SERVICE BULLETIN

ELECTRICAL LOAD CENTER INSPECTION AND REWORK

All MD-900 helicopters, serial number 900-00052 thru 900-00076.

Electrical Load Center (P/N 900E2750620-127), Wire Harness (P/N 900E2760620-125).

Figure 1. Electrical Load Center Component Locations

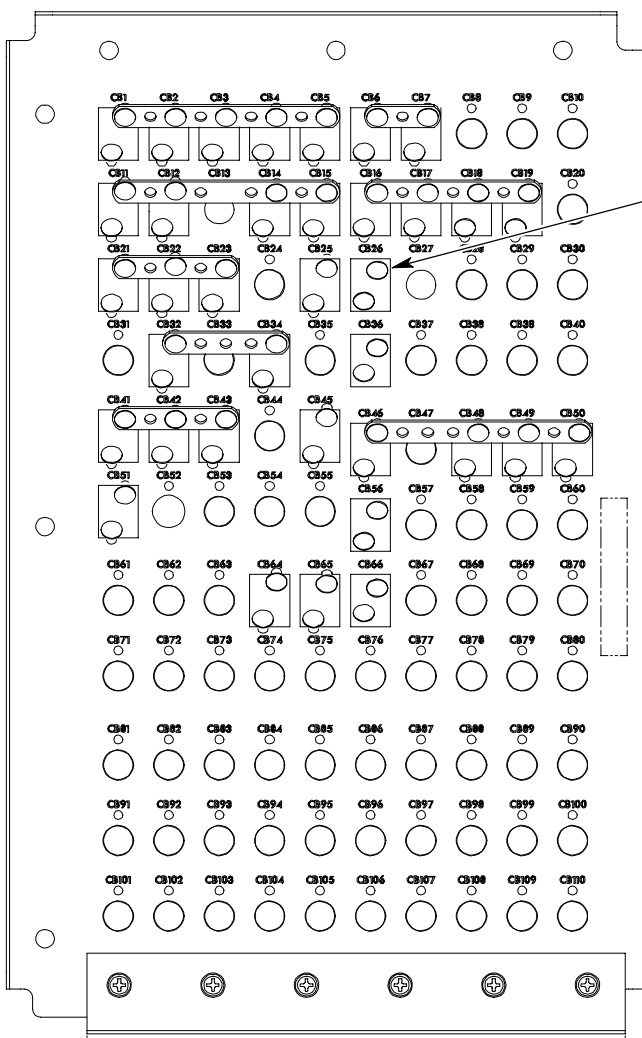
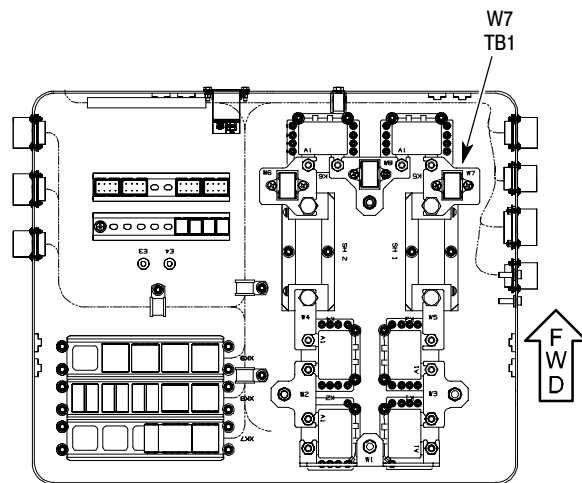
A wire which supplies power to the No. 2 condenser fan circuit breaker was inadvertently omitted on some MD-900 helicopters. This wire is considered part of the basic helicopter design and should be present on all MD-900 helicopters.

(Ref. Figure 1)

- (1). Open baggage compartment door L262 (Ref. CSP-RMM-2, Section 06-00-00, Access Methods).
- (2). Remove baggage compartment roof insulation as required to gain access to electrical load center (Ref. CSP-RMM-2, Section 25-50-00, Insulation Panel Removal).
- (3). Open electrical load center, A620 and check for wire segment P113B12 EMI 3 between CB26-1 and W7-TB1-B.
- (4). If wire segment P113B12 EMI 3 is present, perform step 2.C. Completion Instructions.
- (5). If wire segment P113B12 EMI 3 is not present, continue with Rework Instructions below.

- (1). Fabricate and identify wire in accordance with Wire Build Table and Rotorcraft Maintenance Manual (CSP-900RMM-3).

- (3). Install wire P113B12 EMI 3 from CB26-1 to W7-TB1-B.
- (4). Reidentify wire harness 900E2760620-123 to 900E2760620-125 by ink stamping new number on wire harness identification tag.
- (5). Reidentify electrical load center 900E2750620-127 to 900E2750620-129 by ink stamping new number on box.
- (6). Close electrical load center.
- (7). Test air conditioning system, if installed.
 - (a). Start engines (Ref. CSP-902RFM-1, Section IV).
 - (b). Turn on air conditioning (Ref. CSP-902RFM-1, Section X).
 - (c). Verify that CNDSR FAN 1 circuit breaker, CB56 and CNDSR FAN 2 circuit breaker, CB26 are both closed.
 - (d). Open CNDSR FAN 1 circuit breaker, CB56 and verify air flow is present below baggage compartment door, indicating that condenser fan 2 is functioning.
